South Texas Project
Units 1 and 2
Docket Nos. STN 50-498, STN 50-499
Responses to DSER/FSAR Items;
Containment Leak Rate Test

The attachments enclosed provide STP's response to Draft Safety Evaluation Report (DSER) or Final Safety Analysis Report (FSAR) items.

<u>Attachment</u>	<u>Item No.*</u>	<u>Subject</u>
1	F 6.2-32	Figure 6.2.6-1, Containment Leak Rate Test Pressurization System

**P&ID CONTAINMENT LEAK
RATE TEST (CLRT)
PRESSURIZATION SYSTEM**

Figure 6.2.6-1

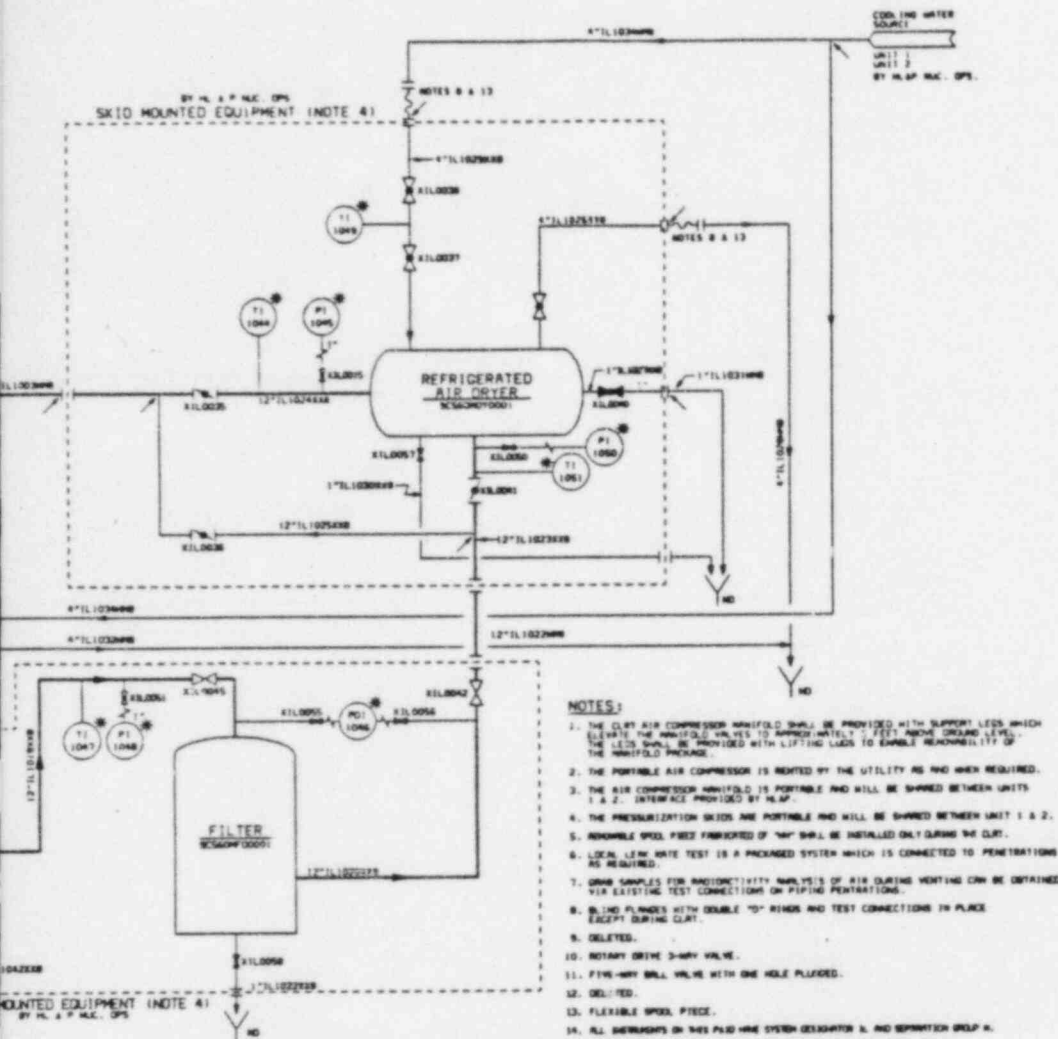
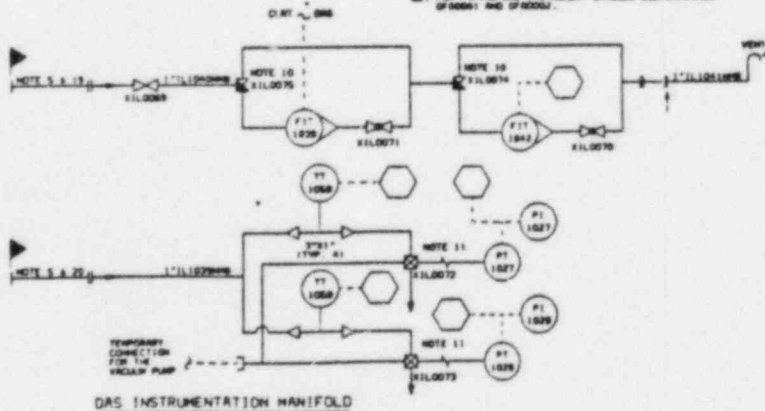
Revised 9/25/85
